FOR THE MEETING OF: October 15, 2020
AGENDA ITEM: 5.b

CASE NO.: Historic Design Review Case No. HIS20-23

APPLICATION SUMMARY: A proposal for replacement of an existing storefront, signage, and sidewalk repair on the Huddart Building.

LOCATION: 234 Liberty Street NE

Single Face Illuminated Wall Display

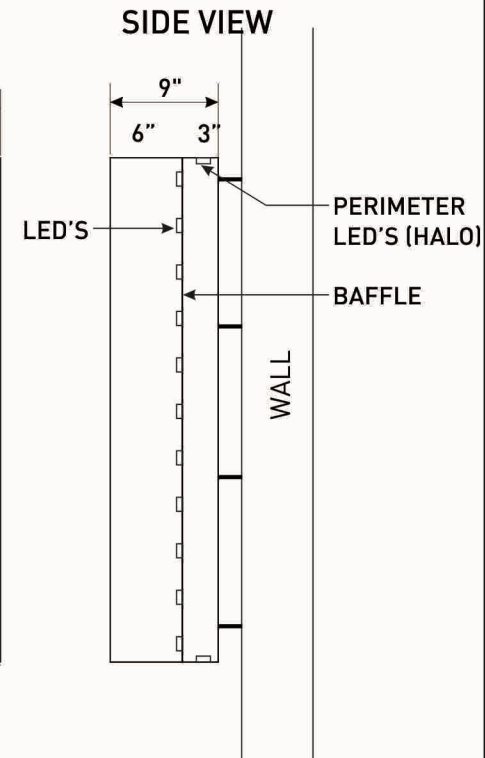
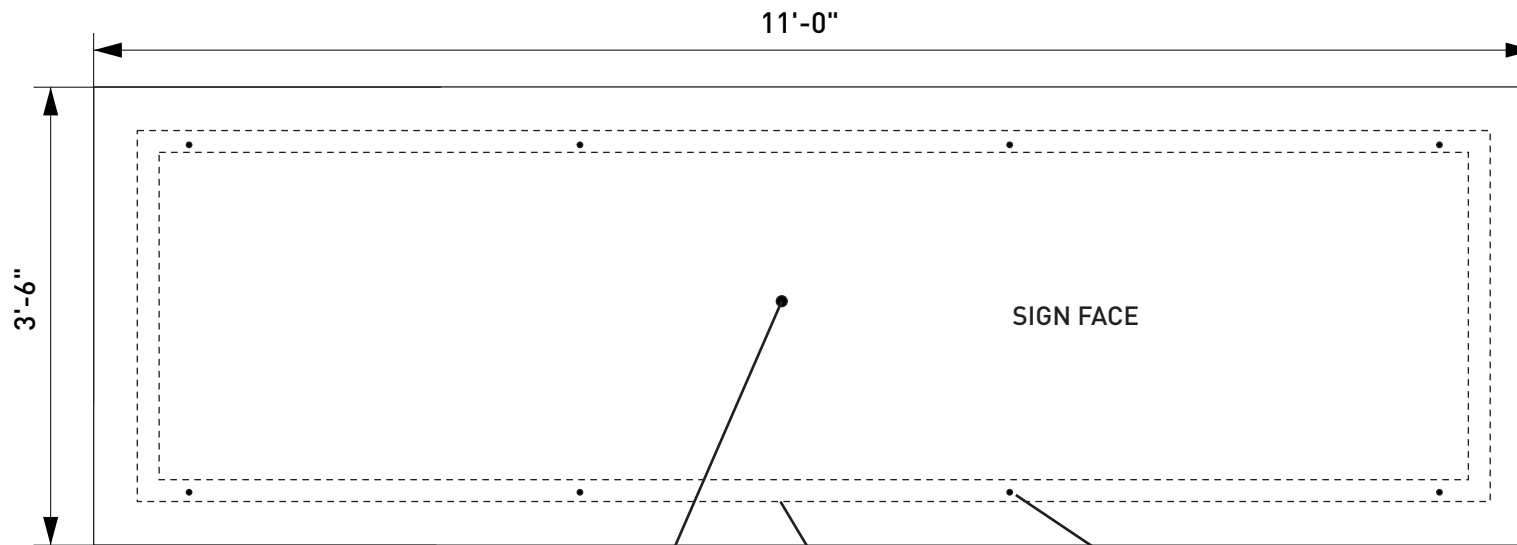
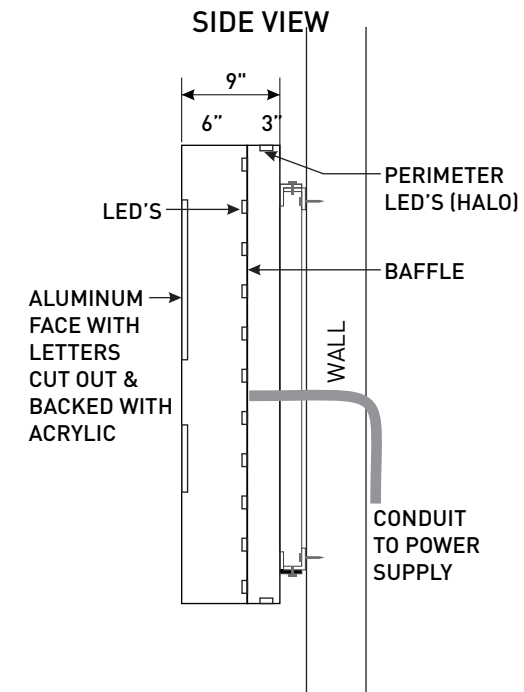
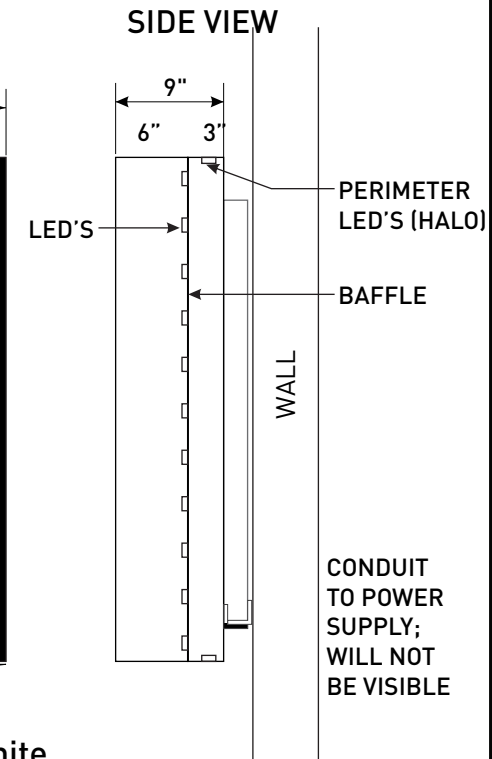
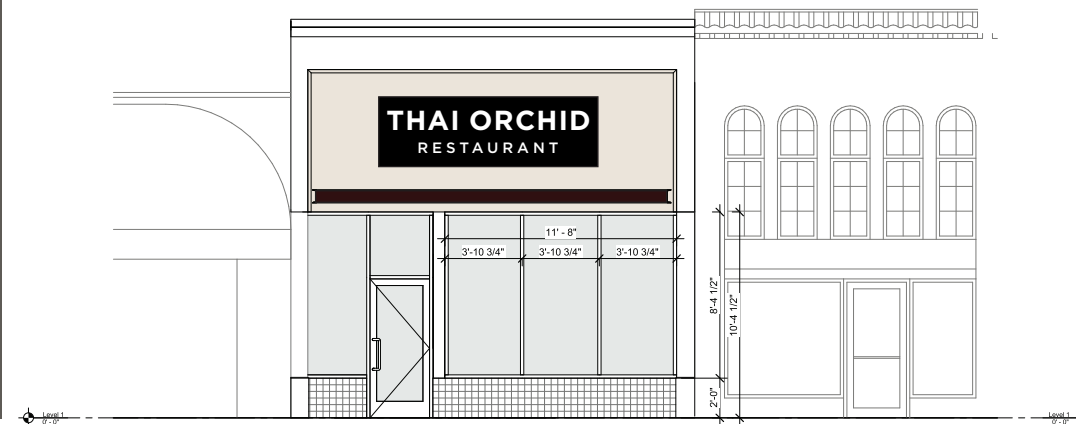
Finding: The proposed signage will be installed flush to the façade of the Huddart building. Staff recommends the HLC find that SRC 230.056(c)(2) has been met for this portion of the proposal.

Finding: The proposed signage is constructed of metal, thereby meeting SRC 230.056(c)(7).

Finding: The proposal does not include free-standing neon or plastic back-lighted boxes; therefore, this standard is not applicable to the evaluation of this proposal. However, the applicant has proposed that the signage perimeter be illuminated by LED's (Halo) and the letters will be illuminated white. This type of illuminated signage is compatible with the Huddart Building and can be found within the Salem Downtown Historic District.

Finding: The proposed conduit for the signage will not be visible, located behind the signage, therefore staff recommends the HLC find that this criterion has been met.

Finding: The proposed signage has light lettering on a dark background, thereby meeting SRC 230.056(c)(13).

Finding: The proposed sign will be attached flush to the façade of the Huddart building using bolts and no historic materials will be damaged or obscured by the installation, thereby meeting SRC 230.056(c)(19).
